# Recall Bulletin

## PRODUCT SAFETY RECALL

**SUBJECT:** Power Seat Height Adjuster Bolt

**MODELS:** 2011-2012 Buick LaCrosse, Regal  
2010-2012 Cadillac SRX  
2011-2012 Chevrolet Camaro  
2010-2012 Chevrolet Equinox  
2010-2012 GMC Terrain  
Equipped with Driver Power Seat Height Adjuster

3969295

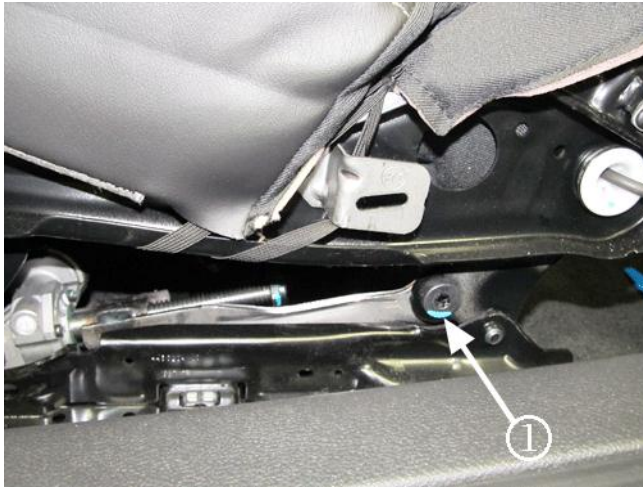
1. Adjust the driver front seat into the fully upward and forward position.

**Note:** It is NOT necessary to remove the adjuster and lever knobs, nor disconnect the electrical connector noted in the procedure below. The finish cover (1) can be detached and repositioned to gain access to the vertical adjuster actuator bolt

3969296

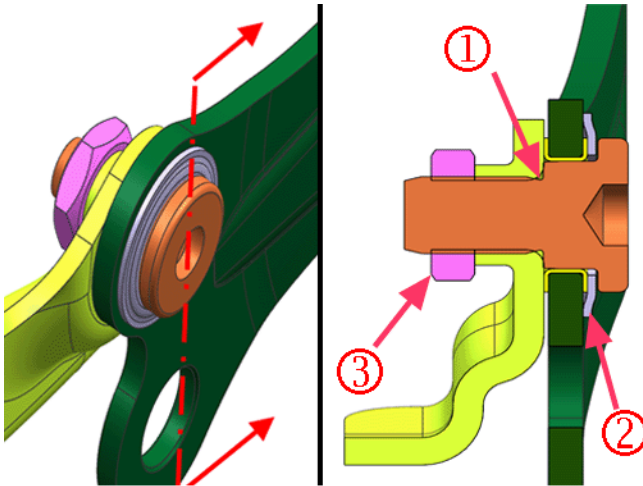
2. Remove the front seat outer adjuster finish cover (1) from the seat. Refer to *Driver or Passenger Seat Outer Adjuster Finish Cover Replacement (with Power Height Adjuster)* in SI.
